1 Q. The costs estimated by Stantec for the ESP and FGD installations in their report are
2 totaled at \$450 million. The price carried in document “Exhibit 5 Summary Capital
3 Cost Estimate” is \$582 million. In discussions with Nalcor on August 17, 2011,
4 Nalcor indicated that there was a capital budget input sheet that was submitted to
5 the System Planning Department which developed these costs. Please describe the
6 progression of these costs from \$450 million to \$582 million.

Holyrood Precipitator/Scrubber Installation

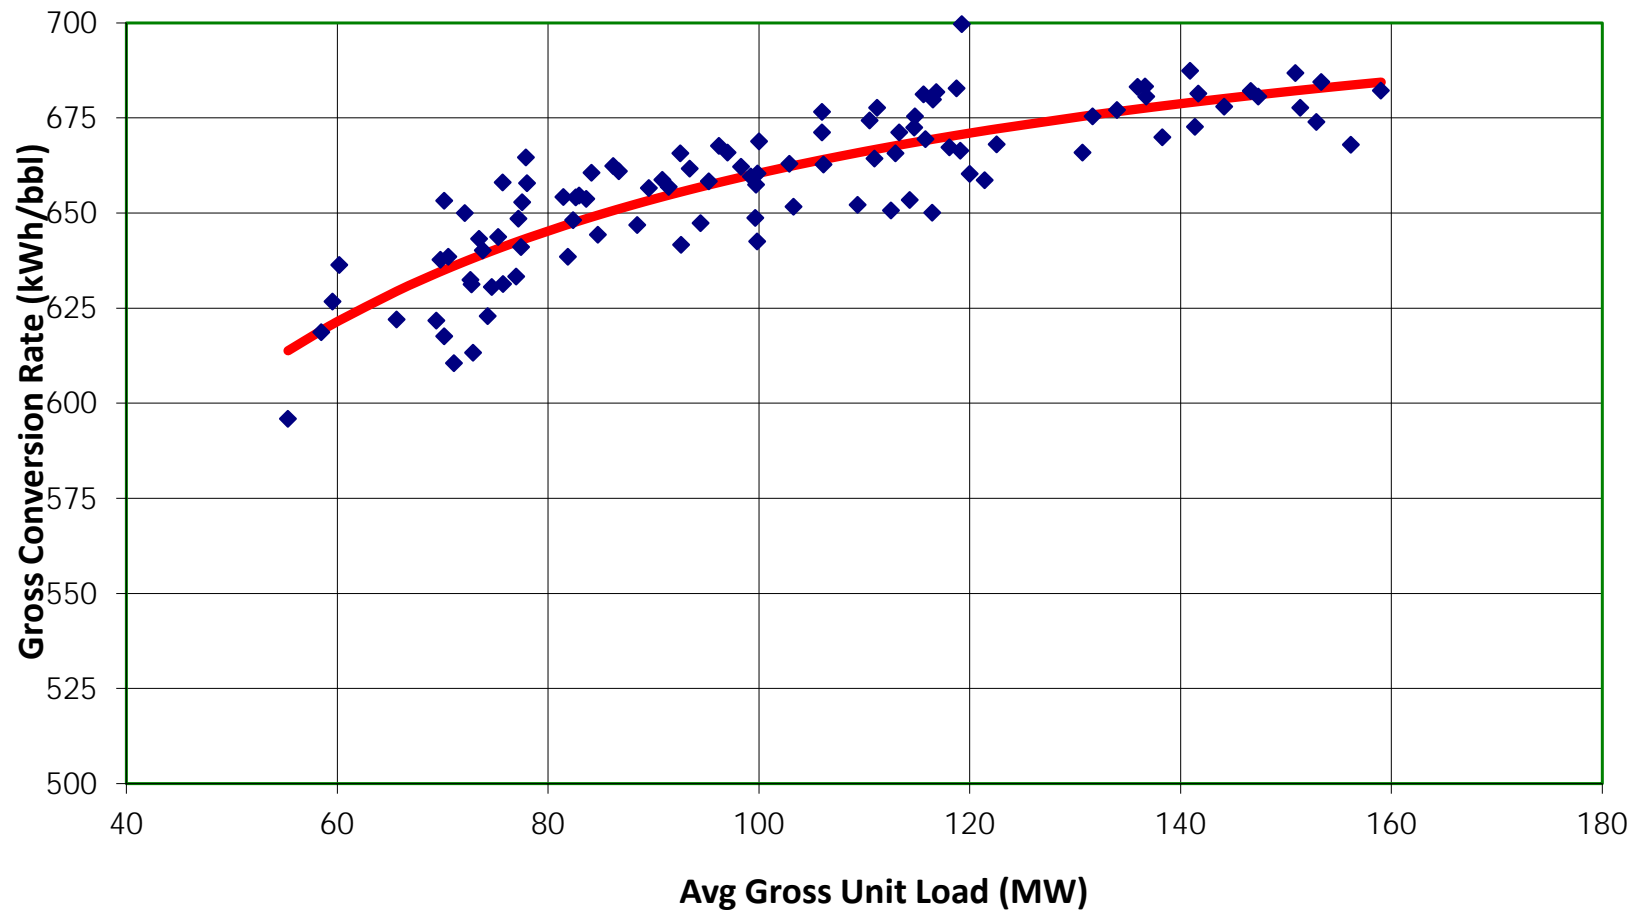
1 Q. Please provide the Operating & Maintenance Cost Summary for Holyrood Station for the
2 next five years for the two options being considered. Also, include the O&M Cost Summary
3 for extending the operation of the Holyrood facility out to 2033 under the Isolated Island
4 Option, and converting the plant to synchronous condenser operation for an additional five
5 years and shutting the plant down under the Infeed Option.

16 The annual O&M costs for the Holyrood site, including the synchronous condensers, were
17 estimated to be \$6.6 million (\$2010) starting in 2021, escalating annually by 2.8%. This
18 estimate is considered to be a maximum, given that opportunities to share the work forces
19 at Holyrood and the Soldiers Pond converter station and to automate the synchronous
20 condensers to provide for remote operation have not been considered in this initial
21 analysis.

23 These optimization opportunities will be considered prior to converting Holyrood to
24 synchronous condenser operation.
